NO: HIFI2-99-007

**SUBJECT:** UNIT RANDOMLY POWERS ON, CYCLES MD DISC TO LOAD/EJECT, RECORD FUNCTION DISABLED

**MODEL (S):** MDS-S38/S39/JE320/JE500/JE510

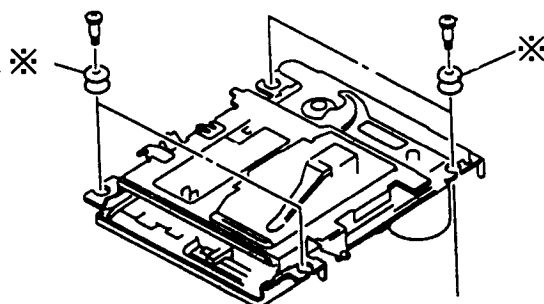
**Solution:** Replace the following components with the improved versions. (Perform the upgrade on sets with applicable serial numbers regardless of the customers symptom.)

REF	FORMER		NEW	
	DESCRIPTION	P/N	DESCRIPTION	P/N
*	INSULATOR	4-987-327-01	INSULATOR	4-987-327-01
S681	PUSH SWITCH (1 KEY)	1-572-467-61	PUSH SWITCH (1 KEY) LIMIT IN	1-572-467-21
S685	PUSH SWITCH (1 KEY)	1-572-467-61	PUSH SWITCH (1 KEY) CHUCKING IN	1-572-467-21
S686	PUSH SWITCH (1 KEY)	1-762-621-21	PUSH SWITCH (1 KEY) PACK OUT	1-762-621-21
S688	PUSH SWITCH (1 KEY)	1-762-621-21	PUSH SWITCH (1 KEY) REC POSITION	1-762-621-21
